**RE: CARAPACE AUTO DEALERSHIP
250 BRIDGE STREET, FAIRHAVEN, MA**

Enclosed are 2 sets of revised plans, supplemental computations and an Operation and Maintenance Program which are being submitted in response to the GCG Associates November 25, 2019 comment letter. Our responses are as follows:

INITIAL ABSTRACTIONS FROM HYDROGRAPHS

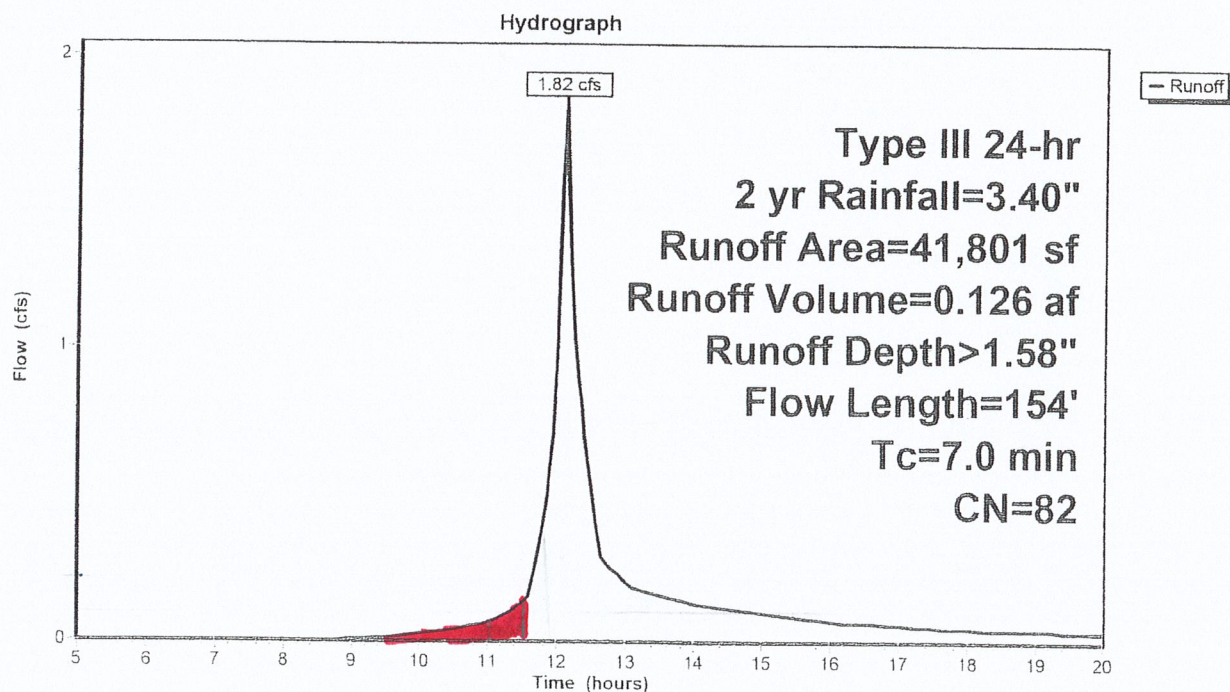
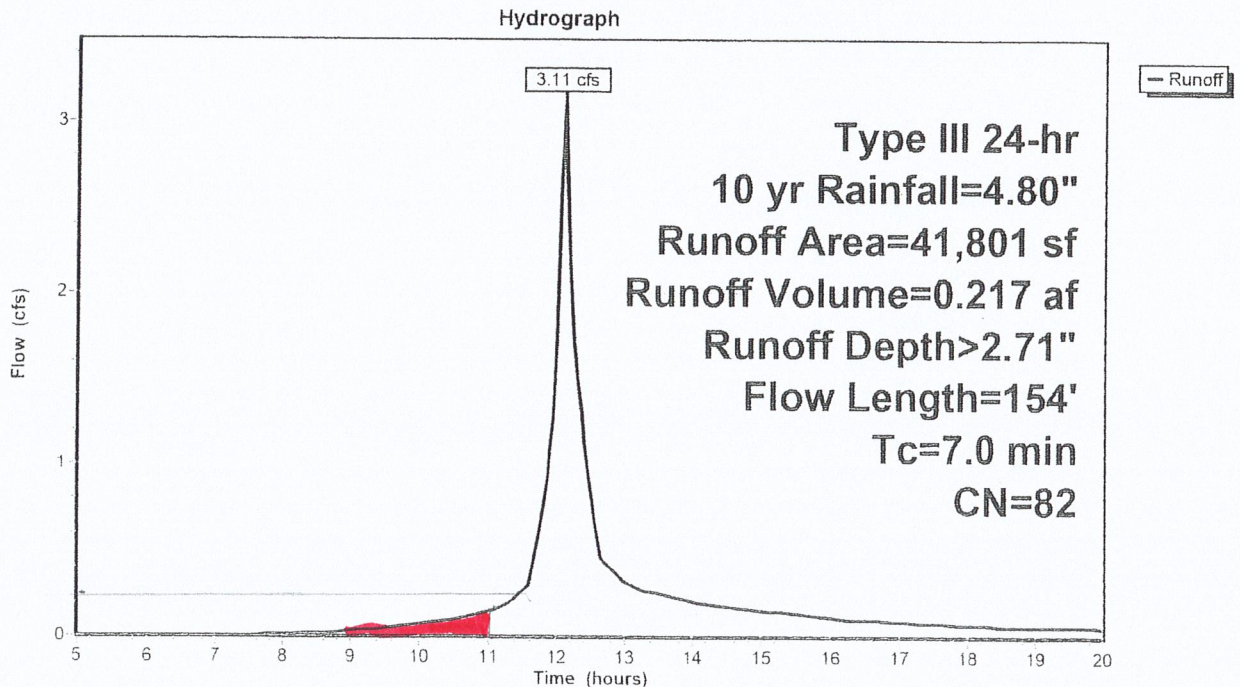
1. Previously developed is not limited to impervious areas. The area east of the existing drive has been maintained as lawn for many years.
2. The shallow swales west of the existing drive only have the capacity to hold the initial 1,800 cubic feet of runoff. Hydrocad software does not allow the addition of this initial abstraction to the computations. On Attachment C, we have shown the initial abstraction on the hydrograph in red. This initial abstraction does not impact the peak rate of runoff. In order to be conservative, we did not model this 1,800 square feet of standing water as impervious with a runoff curve of 98 since this would lead to a higher rate of runoff and a higher peak runoff under existing conditions.
